Model: DF64		Date: 15-Jul-97	No: 1
Modified Article: Parts Catalog Correction		Prepared by: S.Hizen	
From: QAC 1st Field Information Dept.			
Reason for Modification:	<input checked="" type="checkbox"/> Parts catalog correction	<input type="checkbox"/> Vendor change	<input type="checkbox"/> To meet standards
	<input type="checkbox"/> To facilitate assembly	<input type="checkbox"/> To improve reliability	()
	<input checked="" type="checkbox"/> Part standardization	<input type="checkbox"/> Other

MB Correction

Page 9

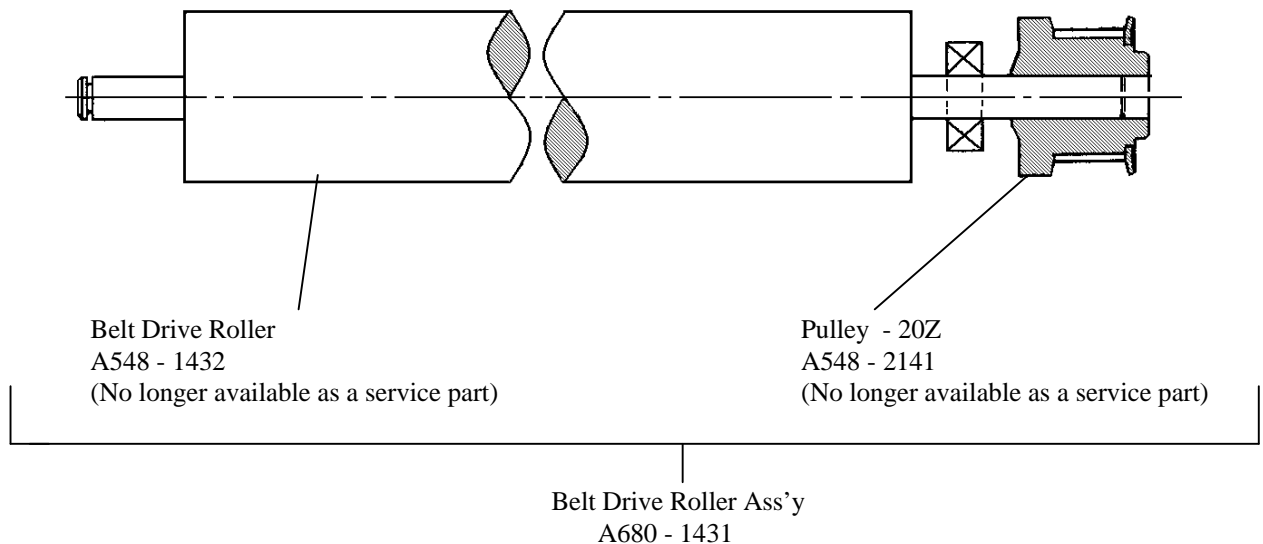
The individual part numbers for the belt drive roller and the 20Z timing pulley are listed in the parts catalog, but the roller shaft is actually press-fit into the pulley on the production line.

The 20Z pulley cannot be installed on the roller shaft in the field. A part number for the belt drive roller assembly has been assigned instead of separate numbers for the belt drive roller and the timing pulley.

Old part number	New part number	Description	Qty	Int	Index	Note
A548-1432		Belt Drive Roller	1		1	
A548-2141		Timing Pulley - 20Z	1		13	
	A680-1431	Belt Drive Roller Ass'y	1	X/O	1

Page 12

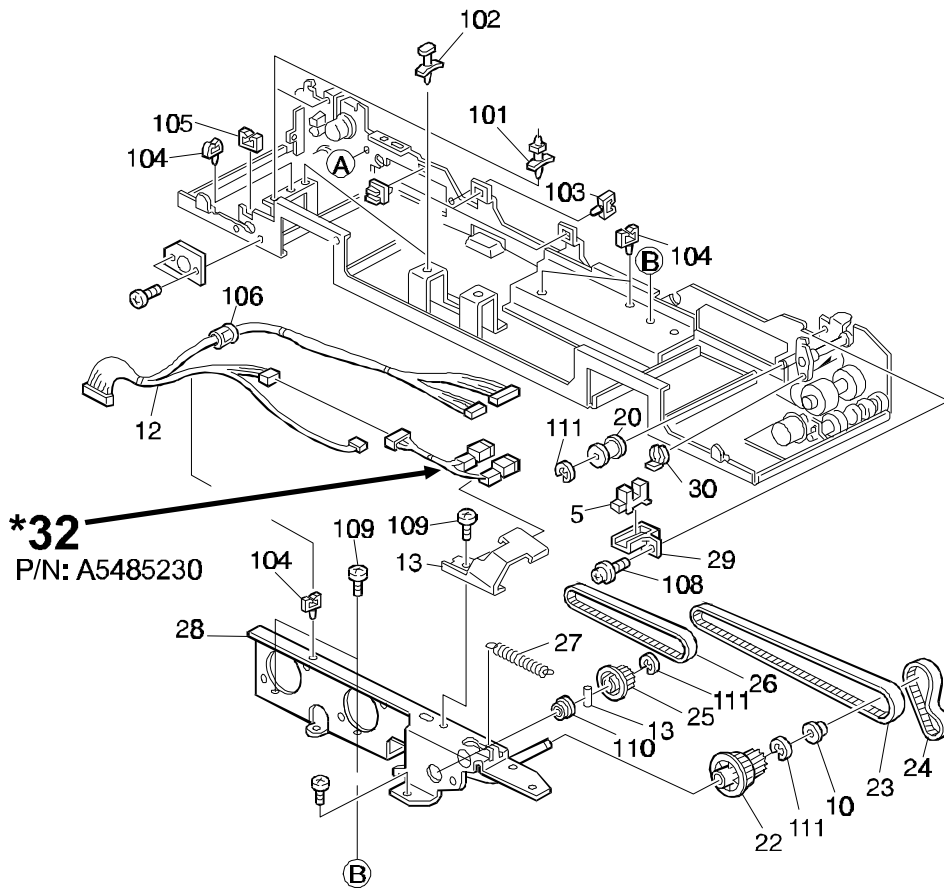
The index number was missing in the following illustration.
Please add the missing number as shown below.

New part number	Description	Qty	Page	Index
A548 5230	Indicator Harness	1	12	32

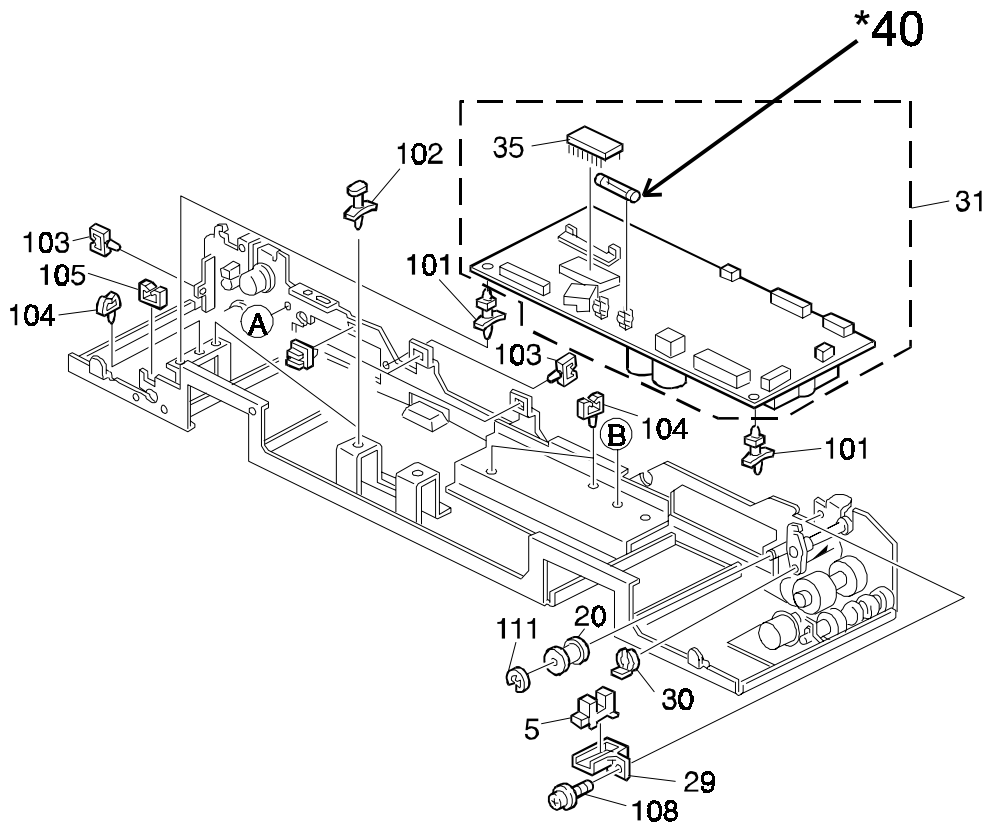
Please add the following part to your parts catalog.

New part number	Description	Qty	Page	Index
1107 0750	Fuse - 3.15A 250V	1	13	40

Page 13

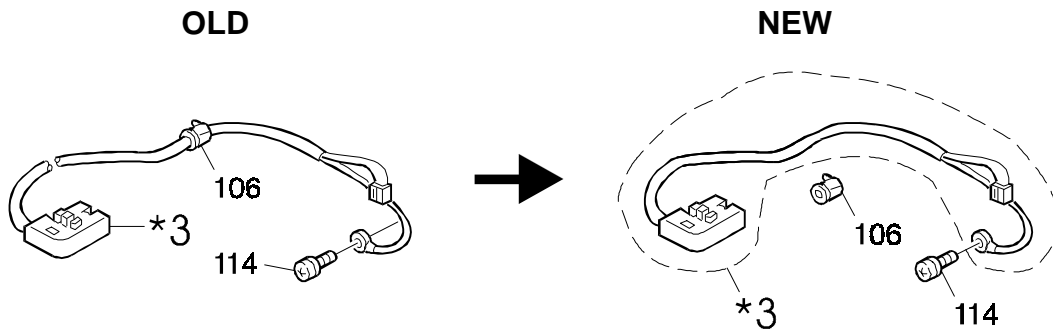
Please correct your parts catalog as follows:

Old part number	New part number	Description	Page	Index
A548 5281	A548 5280	Interface Harness	13	3

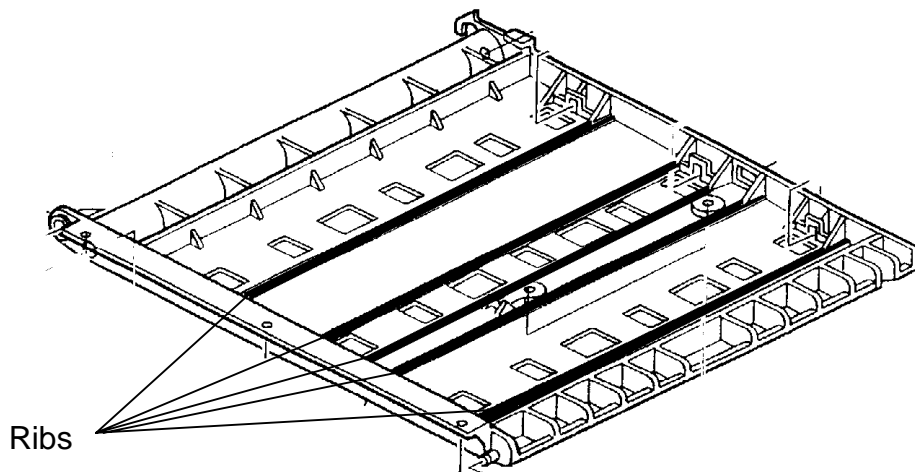
To prevent the transport base plate from being bent, the height of the five ribs on this part has been increased by 17 mm.

If the transport base plate is bent, an original jam caused by the transport belt stopping may occur.

Old part number	New part number	Description	Qty	Int	Page	Index	Note
A5481412	A6631412	Transport Base Plate	1-1	X/O	9	4

Page 12, 13

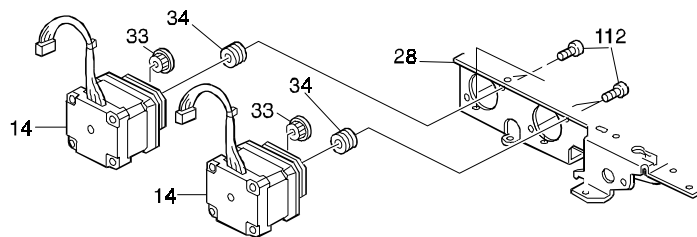
The P/N AX050108 (Stepping Motor: index No.14) does not come with the motor harness. Please add the following part number, and correct the illustration in your parts catalog as follows:

New part number	Description	Qty	Page	Index
A663 5270	Motor Harness	2	13	*40
